823, 833 & 0 DEMING ROAD

Proposed 88-Unit Multifamily Development

Berlin Planning & Zoning, Application for Zone Change, Site Plan Approval & Special Permit

TOWN OF BERLIN PLANNING & ZONING DEPARTMENT STAFF COMMENTS

Turning Performance Analysis

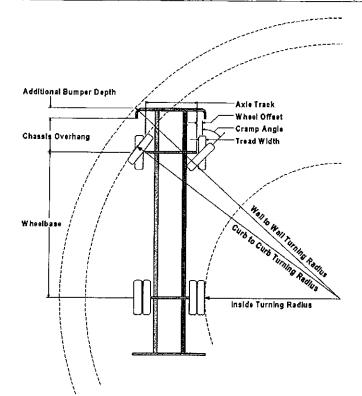
APPLICATION:	Site Plan/Special Pe Eleven Residential	ermit Apartment Buildings (Total of 88 Units)
APPLICANT:	The Metro Group	
LOCATION:	0, 823 and 833 Den	ning Road
AGENDA DATE:	August 6, 2020	
NOTE: If possible	e, please return the plans	with your comments. Thank you.
-		
Department/District: Town Planner Assistant Town Plan Engineering Kensington Fire Dist Worthington Fire Di Board of Education Conservation Comm	trict strict	Building Official Berlin Water Control Health District Fire Marshal Board of Police Commissioners Inland Wetlands Police Chief
i No Comment		
Comments:		
Veal proposed fire Enterior roadway to Meet spe	hydrant layart ay layart echtechten signi	ature/Date
A TOTAL THE	the.	1
appropriate to	Mmy padius	ravrement.
(See AHan	hed)
